# Access Compliance Report

## Public Rights-of-Way

### (Curb Ramps)

Intersection ID: 24751	Main Street: CINNAMON_FIELD_RD	Cross Street: WILD_HEATHER_CT	Location: SW
ADA ID: 1BBAF82ED982	Ramp Type: Perp	Initial Pass/Fail: Fail	Overall Compliance: No Severity Score: 13.75

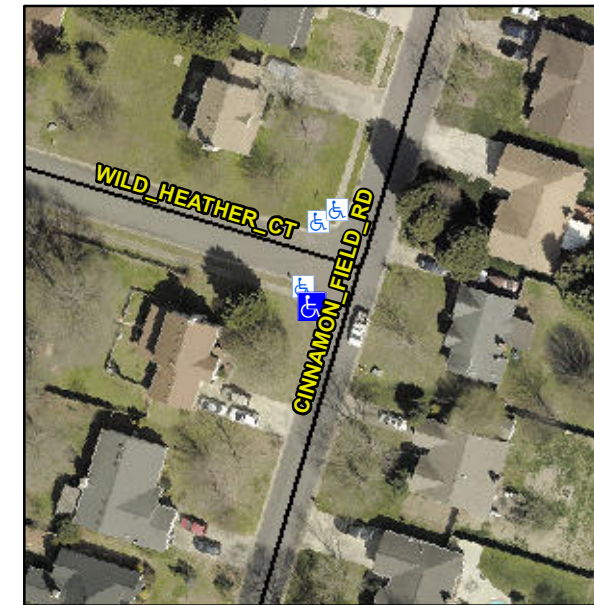
**R304.2.2**

Compliance	Description	Data	Compliance	Description	Data
N/A	Ramp Length (in)	50.0	No	Ramp Slope (%)	10.1
Yes	Ramp Width (in)	60.0	Yes	Ramp XSlope (%)	2.8
N/A	Flare Type LT	N/A	N/A	Flare Type RT	N/A
N/A	Flare Slope LT (%)	N/A	N/A	Flare Slope RT (%)	N/A
N/A	Flare Traversable LT?	N/A	N/A	Flare Traversable RT?	N/A
N/A	Landing Length (in)	N/A	N/A	DWS Provided?	N/A
N/A	Landing Width (in)	N/A	N/A	DWS Contrast?	N/A
N/A	Landing Slope (%)	N/A	N/A	DWS Length (in)	N/A
N/A	Landing X Slope (%)	N/A	N/A	DWS Full Width?	N/A
N/A	Landing Curb? (Y/N)	N/A	N/A	DWS Offset (in)	N/A
N/A	Shared Landing?	N/A			
N/A	Gutter Ponding?	N/A	N/A	Gutter Slope (%)	N/A
N/A	Gutter Lip Ht (in)	N/A	N/A	Gutter X Slope (%)	N/A
N/A	Painted X Walk1?	No	N/A	Painted X Walk2?	N/A
	X Walk 1 Direction	To SE		X Walk 2 Direction	N/A
N/A	X Walk 1 Width (in)	N/A	N/A	X Walk 2 Width (in)	N/A
	X Walk 1 Slope (%)	0.7		X Walk 2 Slope (%)	N/A
	X Walk 1 X Slope (%)	3.7		X Walk 2 X Slope (%)	N/A

**Remove & Replace Entire Ramp.**
